MIL-P-63225A (AR)
AMENDMENT 2
18 MAY 1987
SUPERSEDING
AMENDMENT 1
21 June 1985

MILITARY SPECIFICATION

PROJECTILE, GUIDED, 155MM, M712
CONTROL SECTION FOR

This amendment forms a part of Military Specification MIL-P-63225A (AR), dated 26 April 1984, and is approved for use by the U.S. Army Munitions and Chemical Command and is available for use by all Departments and Agencies of the Department of Defense.

FIGURE 1 Closed loop position gain limits

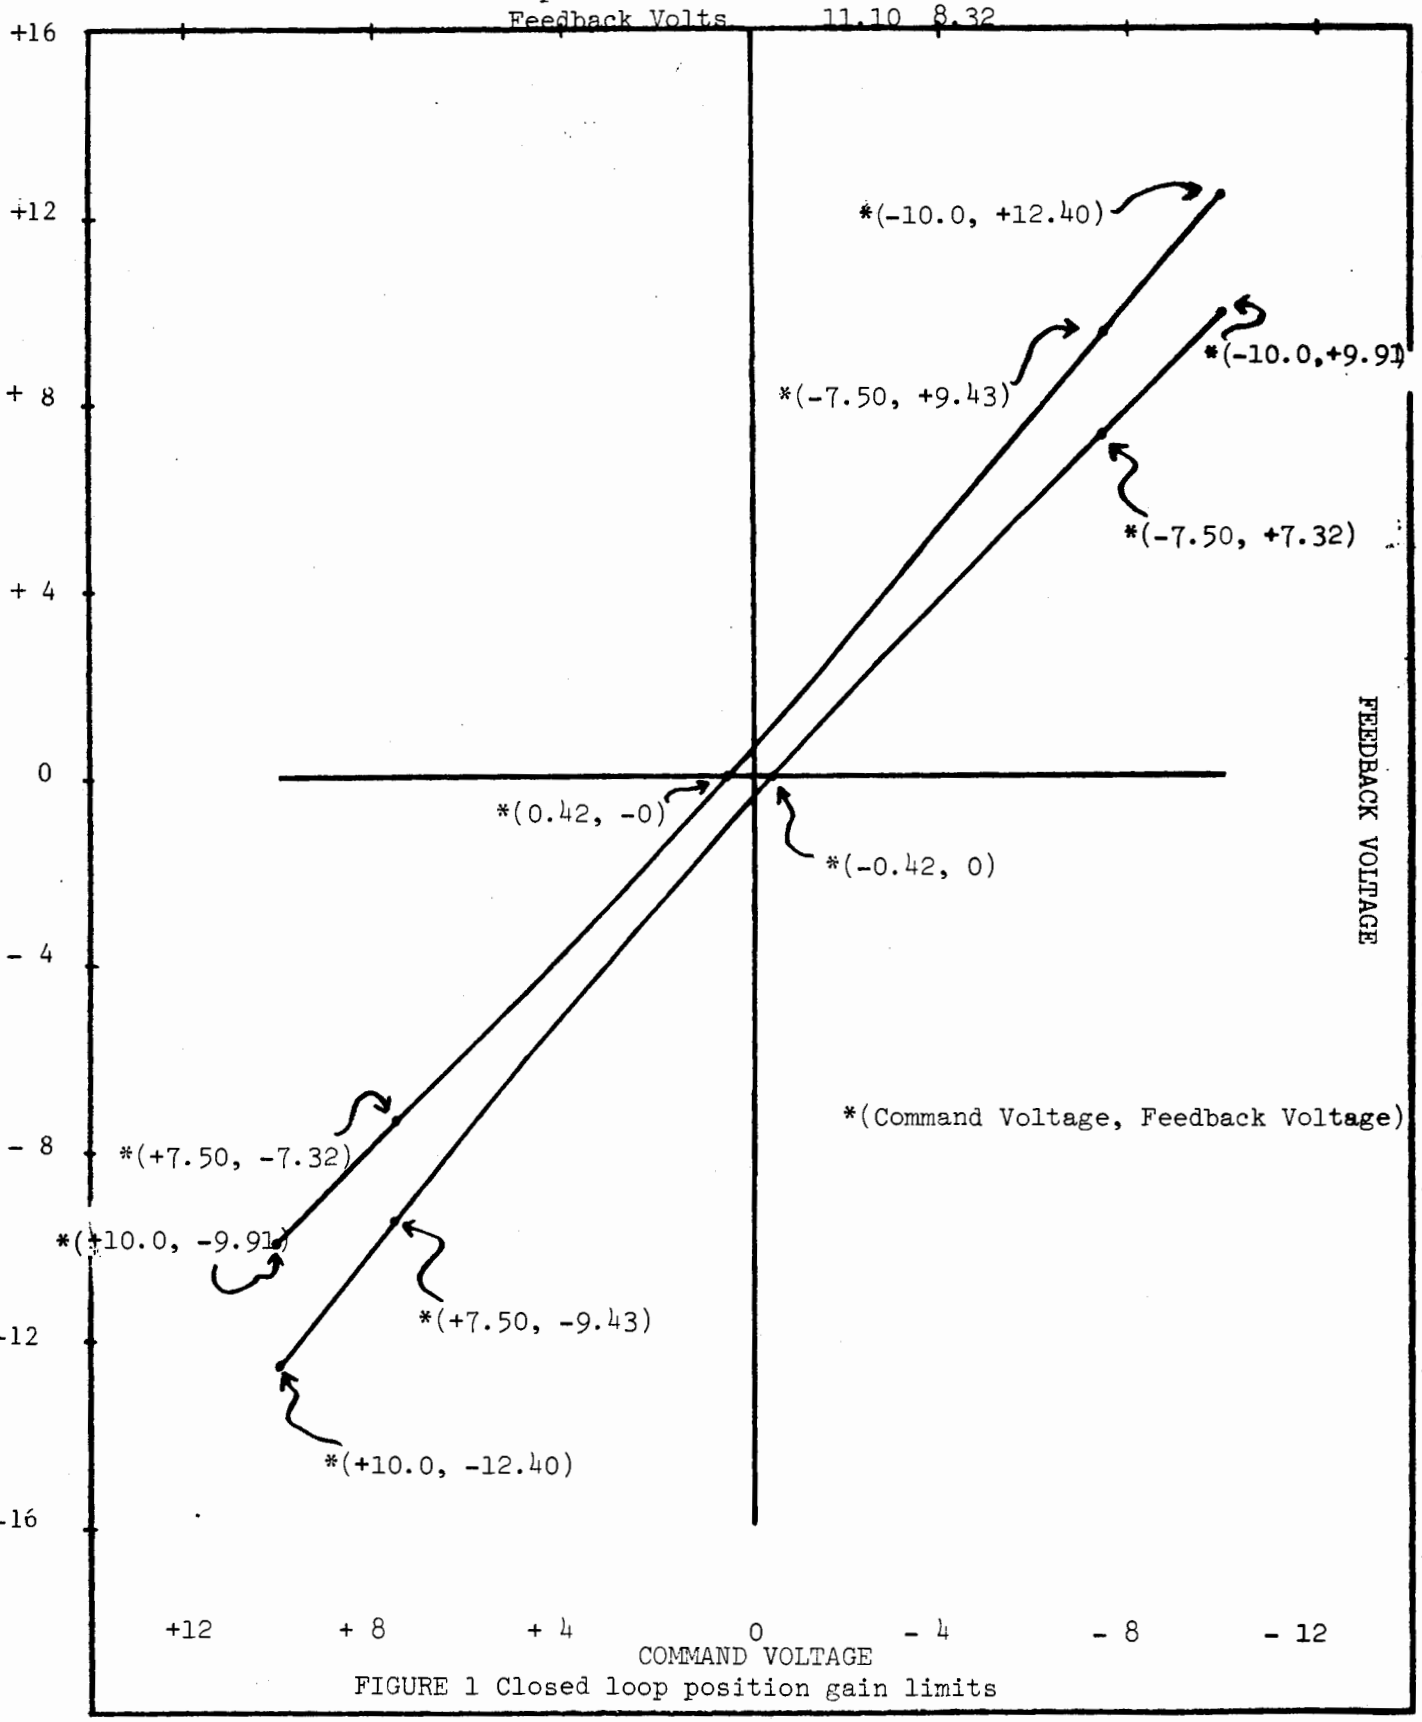
Delete Figure 1 in its entirety and substitute the attached Figure 1.

FIGURE 6

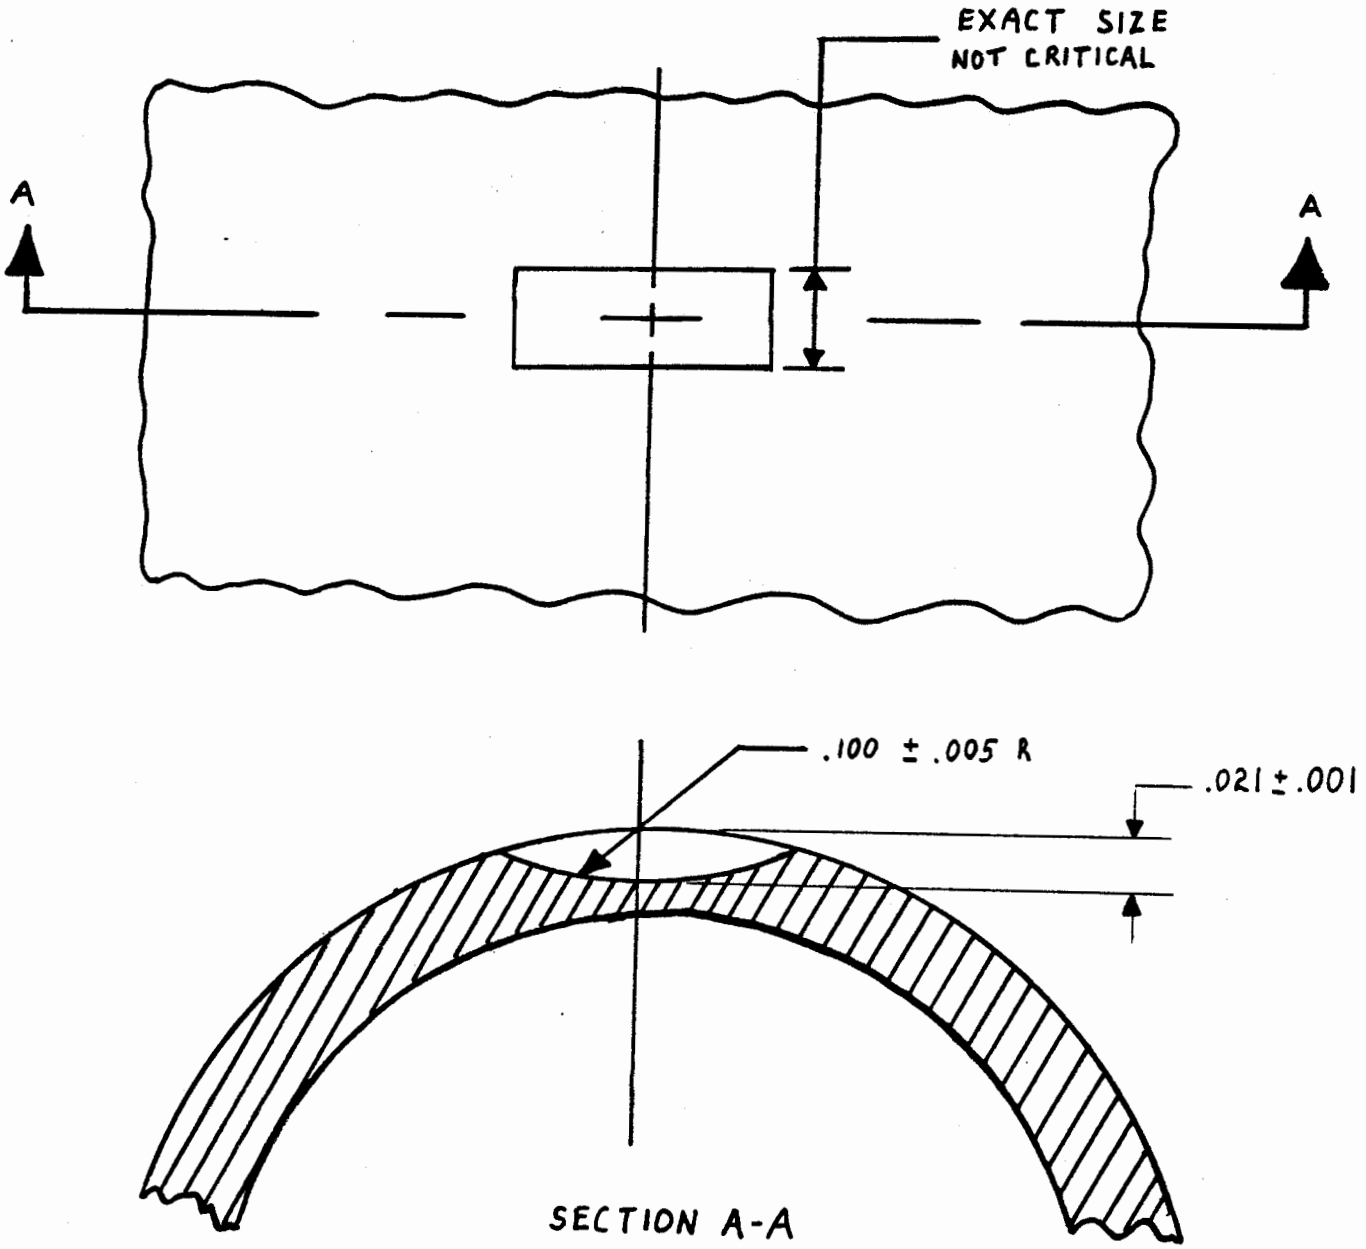
* 3.3.4.1 Ultrasonic examination. The weld zone shall be ultrasonically inspected usin an an le beam method. No discontinuity shall be acceptable which is more than 1DB below that obtained from the least responsive notch in the reference standard per Figure 6.

* 4.5.14.2 Ultrasonic inspection standards. Reference standards shall be of the same thickness, material and configuration as the parts being examined. Simulated discontinuities will be circular segment notches circumferentially cut into the I.D. and O.D. of each weld zone. See Figure 6. For each weld zone I.D. and O.D. there will be 3 notches. One at the near side of the weld zone, one at their nominal center of the weld zone, and one in the far side of the weld zone. The reference standard shall be appropriately treated to inhibit corrosion."

FIGURE 7

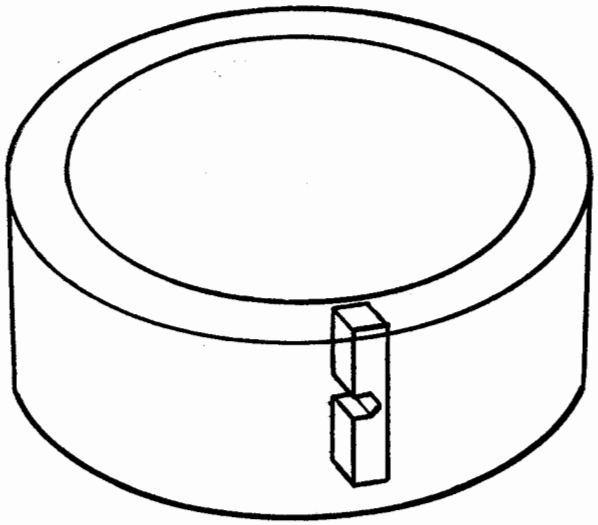
* 4.5.15.2 Fracture toughness specimen selection. Three (3) specimens shall be taken from the housing that exhibited the high ultimate strength readings (above 280 Kpsi). If both housings exhibit high ultimate strength readings then the housing with the highest hardness reading shall be used for specimen selection. The three specimens shall be selected in the longitudinal direction and taken from the aft end of the housing. The specimen shall have a crack plane orientation L - C as shown in Figure 7. The specimen dimensions shall be within the tolerances shown in Figure 9.
